LETTER OF OBJECTION

Prepared by Get Planning & Architecture against application 2019/5709/P,
which is for:

*" Erection of two storey plus basement building, to provide 2 x 3 bed units.
Excavation for basement extension with front light well and rear sunken
garden. Demolition of 12 garages and erection of 5 replacement garages at
Parsifal House, 521 Finchley Road, London NW3 7BT"*

19th December 2019

ABOVE: Application site as proposed with new developments highlighted in red.

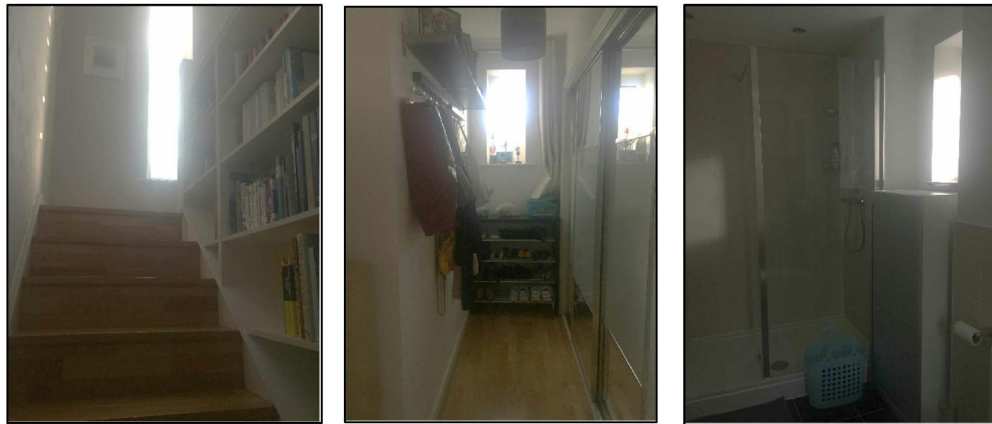
- a. Parsifal House (521 Finchley Road) is a building comprising of 14 flats with 12 garages to the rear of the property. The proposal is to demolish the rear garages and erect a 2 storey building plus basement level adjacent to the existing boundary with sunken gardens and 5 new garages.

- b. Mr Wong and his family are concerned that, due to the proposed placement of the new building, the proposal will greatly affect available sunlight to their property on the NW elevation where the development will be directly opposite. The 2 storey extension would potentially overlook and greatly affect the amount of natural light to their roof garden and will deprive 1G of natural light to the bedroom, bathroom and the single stair circulation space.

ABOVE: Diagram showing the accurate position of 1G Parsifal

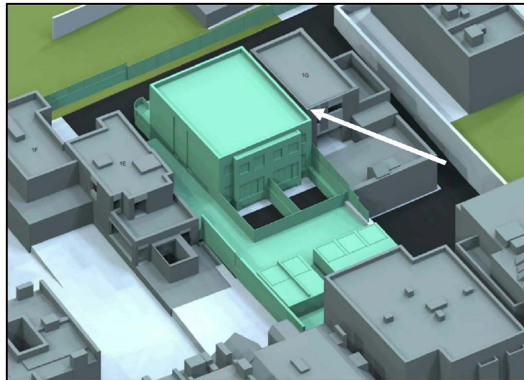
- d. The drawings, particularly the plans and elevations, appear to show inaccuracies in regard to the distance between 1G and the boundary line, illustrating a larger gap between the development and 1G, seen in the figure above. The drawings are also missing window locations on 1G, though clearly indicated within other neighbouring properties. Given the proposals proximity to 1G Parsifal this is surely and unacceptable oversight within the drawings.

- e. Accurate data or plans were not requested from the occupants at 1G. Indicative if not accurate floor plans for this property could have been obtained from a planning search of Camden Council as drawings were submitted in an application by the occupants of 1G, an application that was listed in the Design and Access Statement's planning history.

ABOVE: View of existing alleyway and View from Garden where proposed building will protrude past 1G building line.

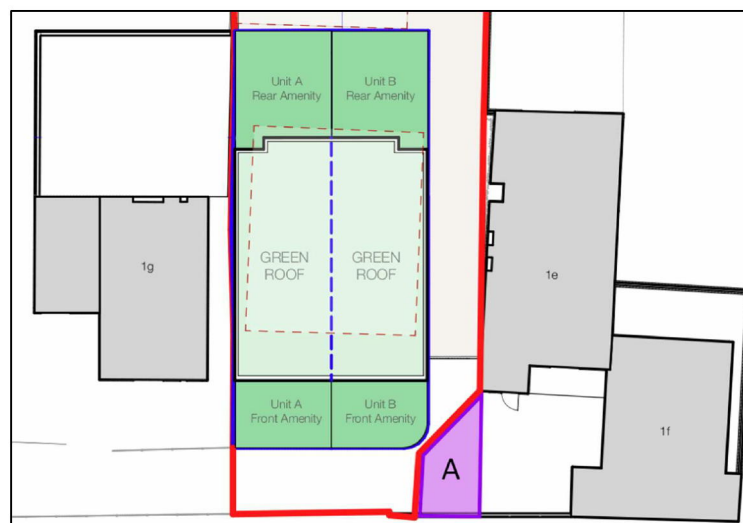
- b. 1G Parsifal currently has an approx. 1.1m wide alley way, which was measured on site by GPA Chartered Town Planners, used for access to the garden from the front of the property and store for bins. The proposal is intended to be built directly on the boundary line which only accentuates its size on the neighbouring property by effectively limiting natural sunlight and creating a dark, tunnel-like space in the area.

- d. It should also be considered that its proximity to the boundary line leaves less than 1.2m between a solid wall and 1G Parsifal Road. This is surely not enough distance between two detached houses, and will result in a cramped and overbearing on the street scene.
